United Energy 2026 - 2031 Regulatory Proposal

REVIEW OF ASPECTS OF PROPOSED EXPENDITURE ON AUGEX AND VEGETATION MANAGEMENT

Report prepared for:
AUSTRALIAN ENERGY
REGULATOR (AER)
August 2025

Figure 3.2: Sub-transmission network in the Mornington Peninsula

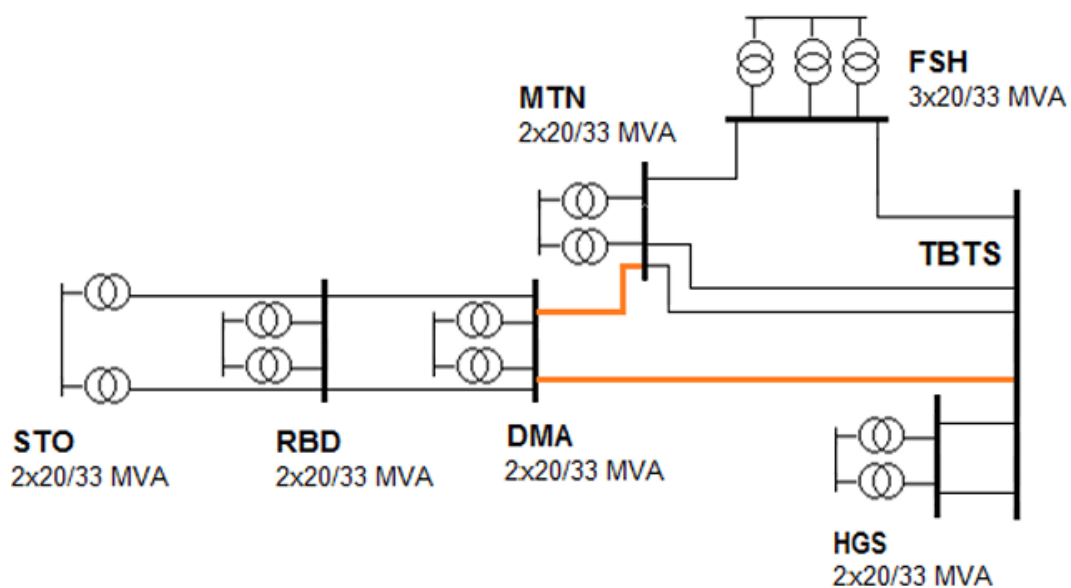
142. Figure 3.2 shows the sub-transmission network in the LMP comprising the DMA, RBD, and STO²⁸ zone substations and the connecting sub-transmission lines.

*'The LMP is vulnerable to voltage collapse if one of the sub-transmission lines supplying the LMP zone substations fails if combined demand at DMA, RBD and STO exceeds 123MW. Voltage collapse would lead to a widespread outage across all of the LMP zone substations.'*²⁹

Figure 3.3: Seasonal load profile of LMP (MW)

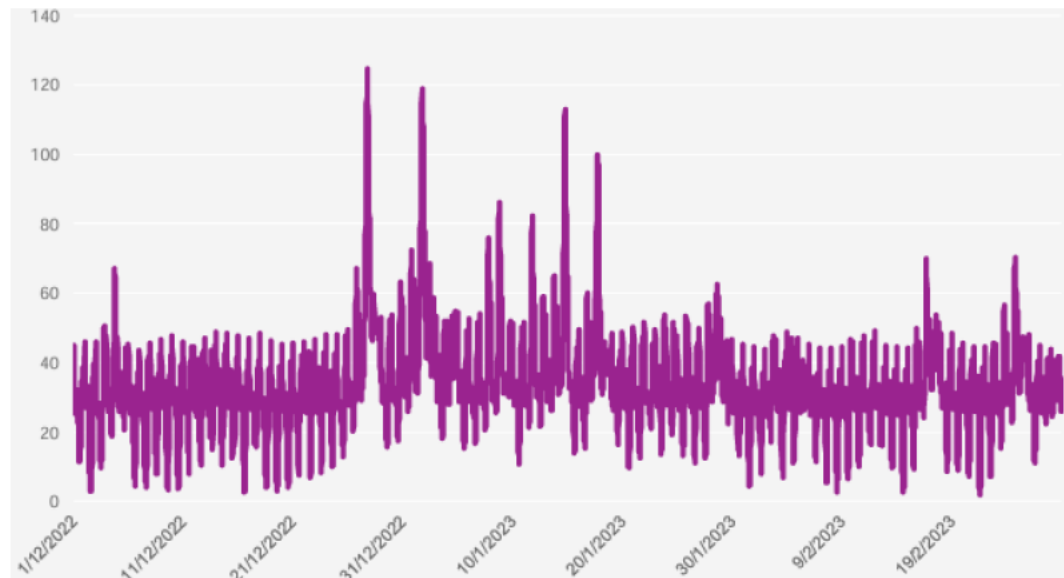
144. As shown in Figure 3.3 there are four pronounced peaks in demand per year (during the holiday peak period over Christmas to late January) at which the demand can be up to double the standard summer peak load. The likelihood of a coincident outage of one of either the TBTS³⁰ to DMA or Mornington (MTN) to DMA sub-transmission lines during the summer holiday period at a time of extreme load is very small but possible. This probability of occurrence limits the exposure of the LMP to voltage collapse.

Figure 3.4: Undervoltage non-compliance of Victorian DNSPs (%)

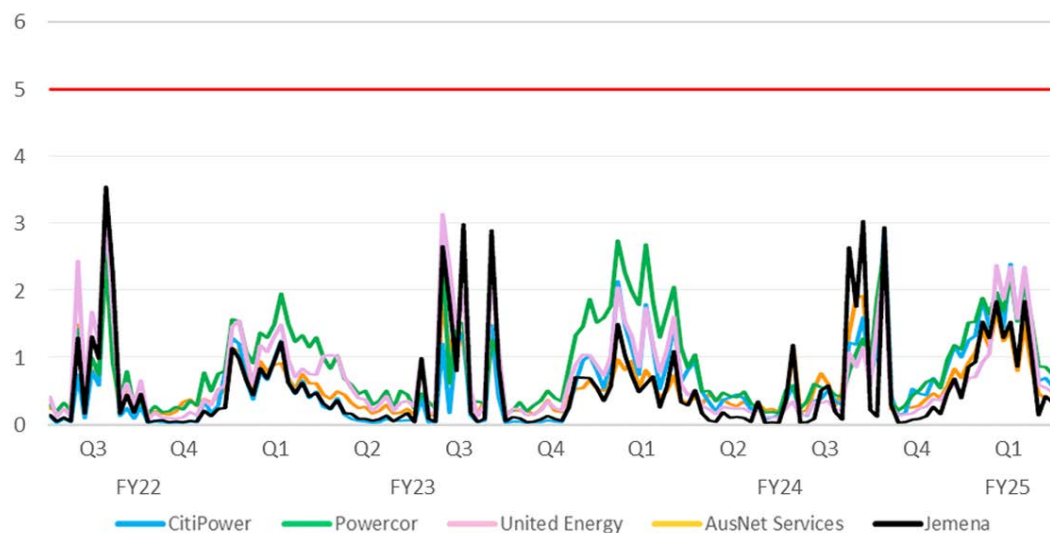
180. United Energy's undervoltage performance is shown in Figure 3.4, with its current service level at 97.5%. However, with the extent of electrification forecast over the next RCP, United Energy's new time-series modelling capability⁴⁸ indicates that undervoltage issues will increasingly arise. United Energy claims that this will lead to malfunctioning appliances, EVs not charging, flickering lights, curtailed PV export, increased energy costs, and reductions in the lifespans of electrical equipment.

Figure 3.5: United Energy projection of voltage compliance forecast - 'do nothing' scenario (%)

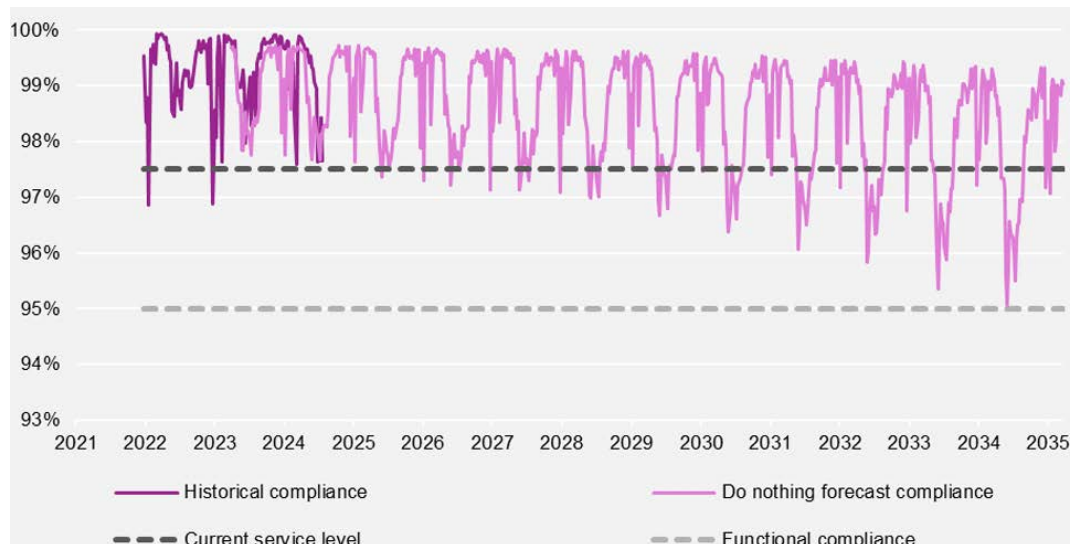
181. United Energy claims that the result of a modelled 'do nothing' scenario is for a level of non-compliance at 96.4% by FY31, as shown in Figure 3.5. United Energy claims that this

approach will inevitably and progressively lead to more customer complaints related to undervoltage during the next regulatory period, despite technically not breaching the functional limit (at least according to the modelling) either within this period or, it appears, until sometime beyond 2035.

Figure 4.1: Historical and forecast expenditure - \$m FY2026

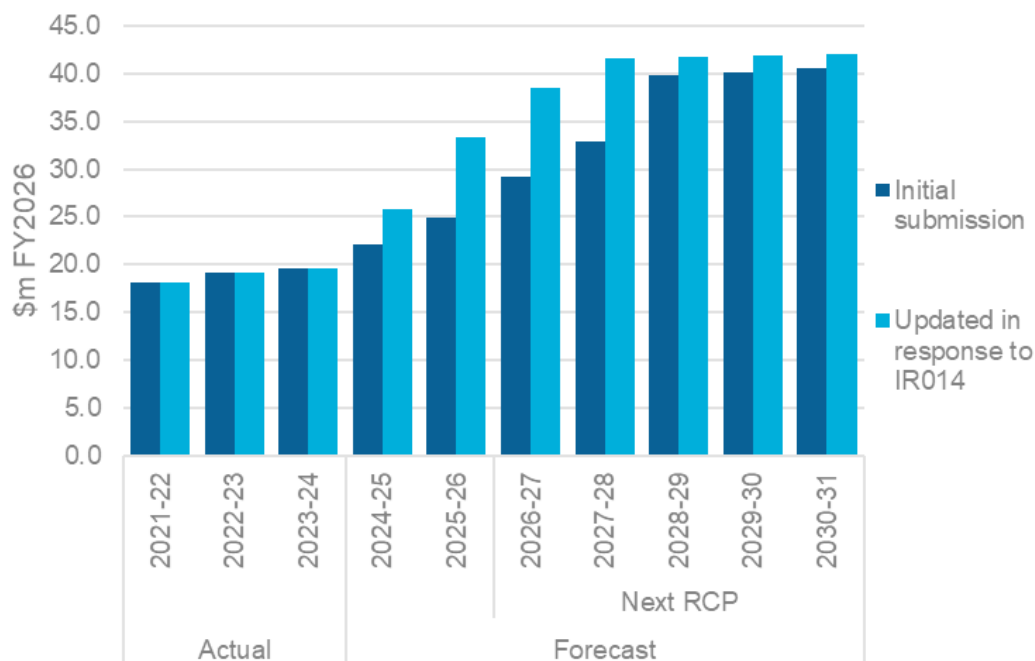
257. The historical expenditure shows a rapid increase from FY22 based on the RIN as shown in Figure 4.1. This increase is forecast to continue into the next RCP, before leveling out in FY29 when United Energy considers that it will have achieved its line clearance obligations, and thereafter will move into maintaining compliance.
258. As a part of its response to IR014, United Energy states that it can achieve compliance one year earlier, in FY28.

Figure 4.3: Historical and forecast vegetation management spans that are required to be cut

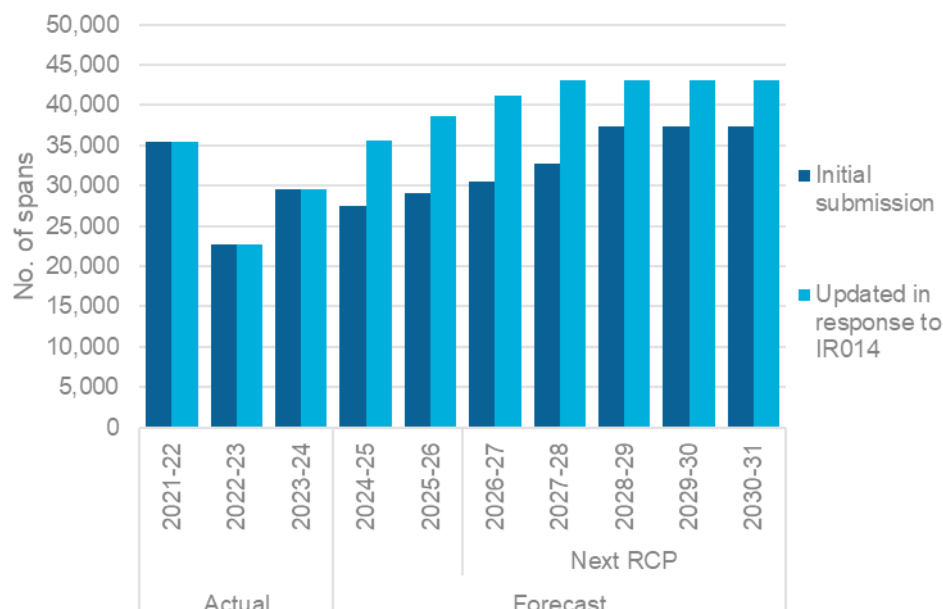
268. In Figure 4.3 we show the trend in volumes. We had expected to see a similar profile on the basis that the cutting volumes are a large driver of the costs. However, we observe a higher increase in volumes in IR017 than has been included in the initial submission, and a slightly lower starting volume in FY25.

Figure 4.5: Historical completion volumes

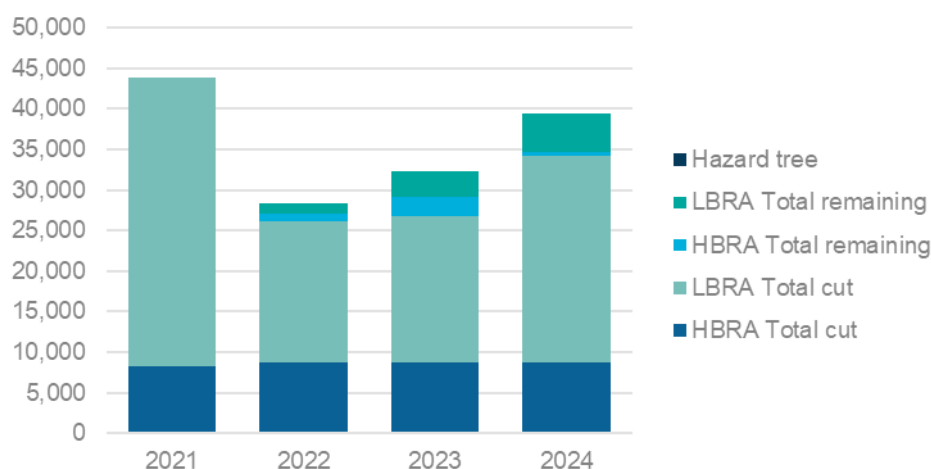
274. In response to our request for information, CPU provided data of its vegetation program for each of the businesses. In Figure 4.5 we have separated the data into United Energy's

completed cutting (HBRA and LBRA), hazard trees and remaining. In this way we can see the total volume of work identified for United Energy's network.

Figure 4.6: Volume of HBRA spans over the period 2022 to 2024

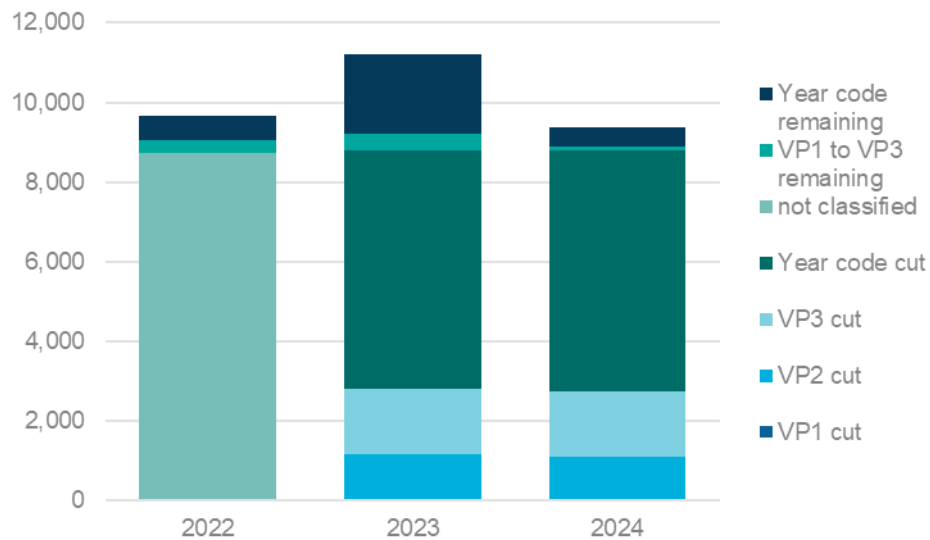
281. As discussed previously, we would expect VP rectification cuts to decrease over time once compliance has been achieved.
282. In Figure 4.6 we illustrate the impact of United Energy's priority focus on vegetation management in the HBRA region, which shows that whilst the maintenance cutting (year code cutting) has increased over this time, the number of spans requiring VP rectification cutting has not. In fact, overall, the total number of HBRA spans have been decreasing slightly.

Figure 4.7: Trend of average vegetation management unit rates - \$, FY2026

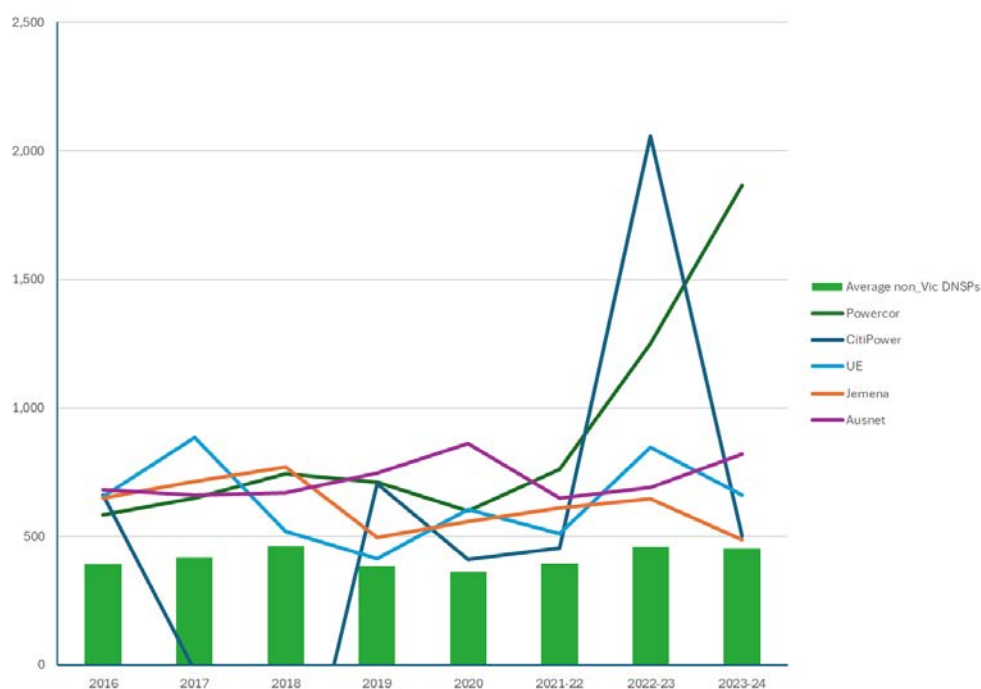
288. We considered unit rates over time in Figure 4.7 and noticed that the Victorian DNSP unit rates were largely flat in real terms, with United Energy showing an increasing rate in the recent years.

Figure 4.8: Vegetation management opex per km of overhead length (\$2023) - average 2019-23

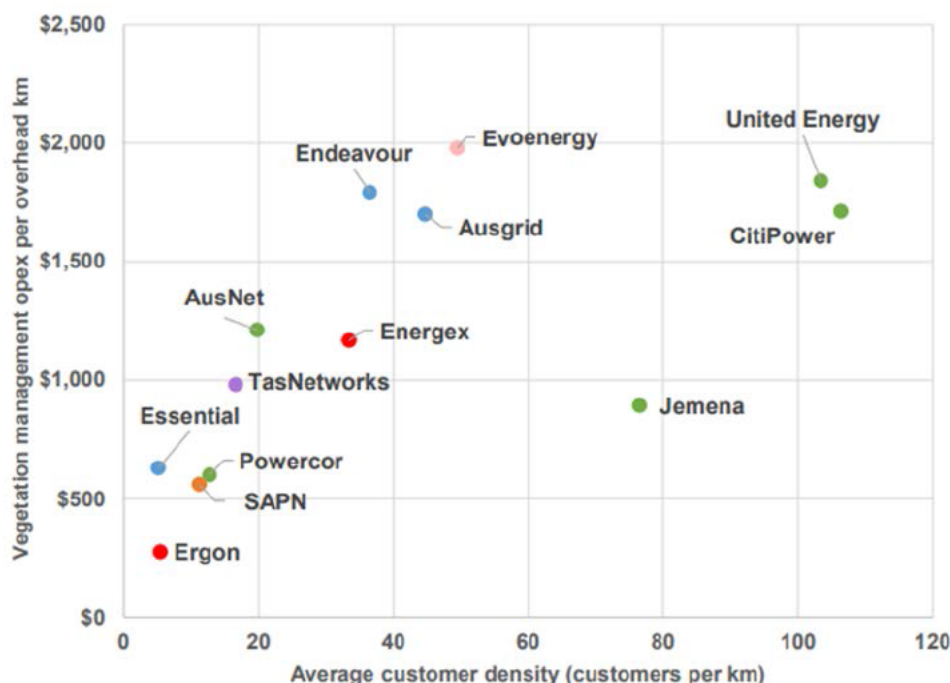
293. In the AER's 2024 annual benchmarking report, CitiPower and United Energy are identified as having amongst the highest vegetation management expenditure per kilometre of overhead circuit line length in the NEM, whilst Powercor is identified as having one of the lowest. We reproduce the analysis relied upon by the AER in Figure 4.8.

Figure 4.9: Average vegetation management opex per maintenance span km versus customer density

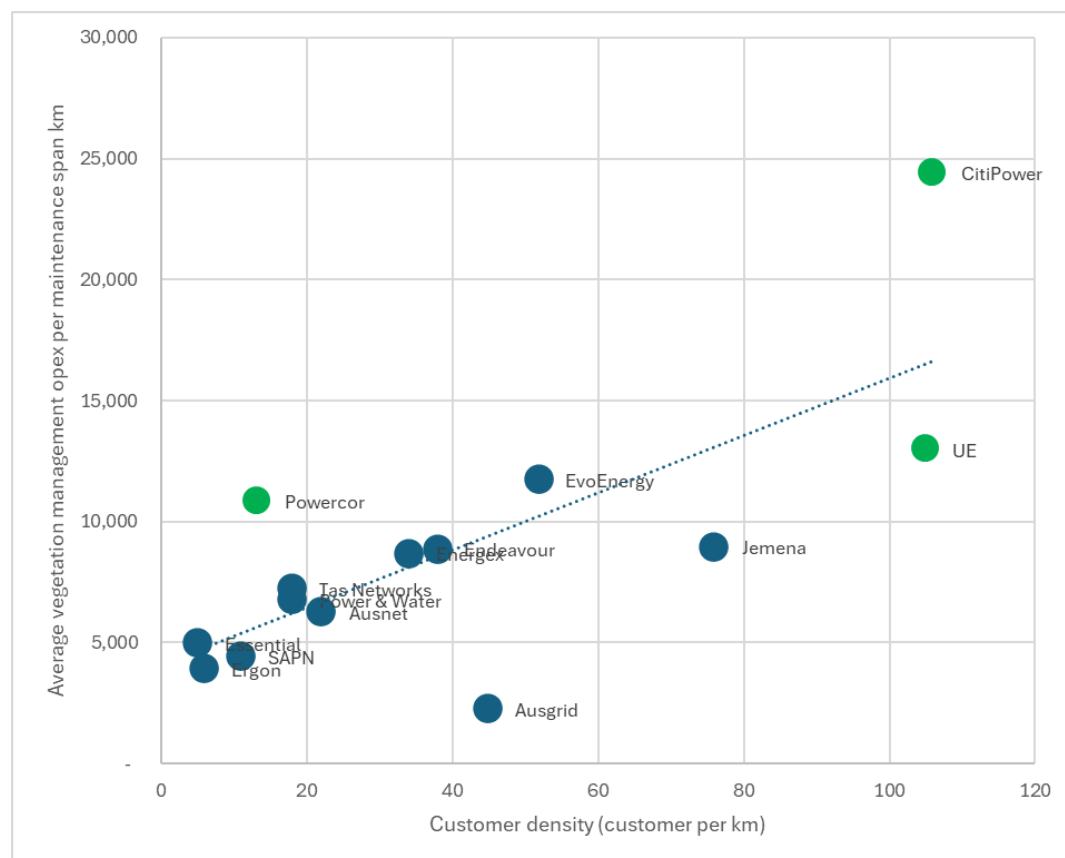
295. We undertook our analysis of the RIN data to understand the relationship between the three-year average vegetation management opex per maintenance span km. The results are shown in Figure 4.9. Whilst the results are similar for many of the DNSPs, the results for CPU businesses indicate a higher opex per maintenance span than as indicated in the AER benchmarking for overhead line length. We consider that this is due to a lower number of spans identified as requiring vegetation maintenance for the CPU businesses.

Figure 4.10: Average vegetation management unit rate versus customer density

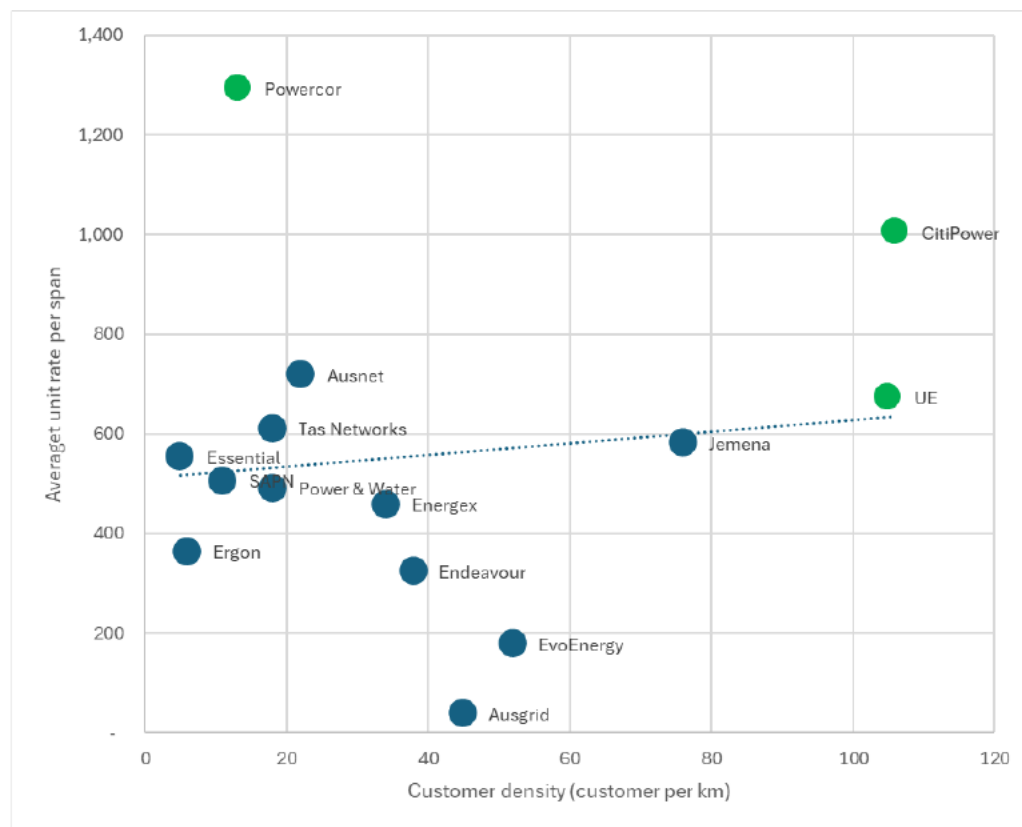
296. We also considered the average unit rates over the same period as shown in Figure 4.10.

Figure 4.11: Comparison of 3-year vegetation management unit rates (FY22-FY24) - \$, FY2026

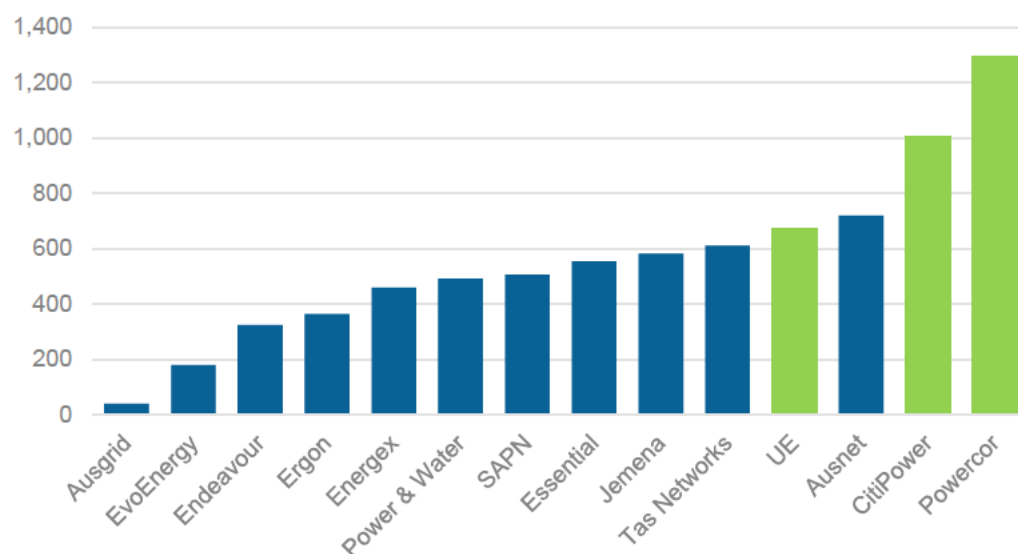
297. Using another representation, using the same three-year averages, we see in Figure 4.11 that United Energy are at the top-end of historical unit rates.

Figure A.1: Powercor example of voltage simulation and assumed ‘energy at risk’

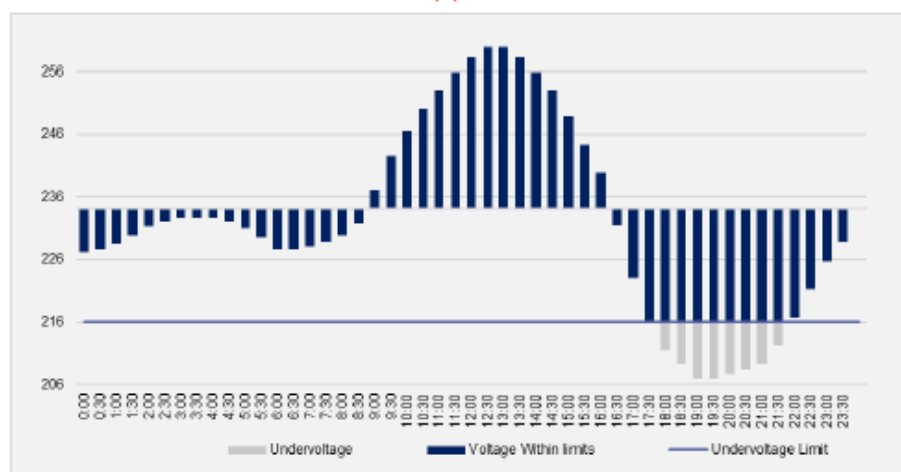
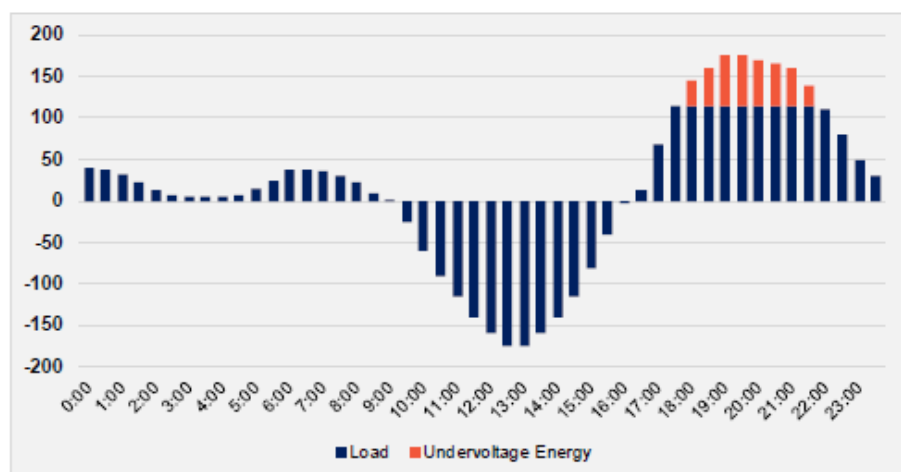
338. Powercor provides the diagrams shown in figure A.1 to illustrate how its half-hourly simulation of voltage is transformed to an assessment of ‘energy at risk’.
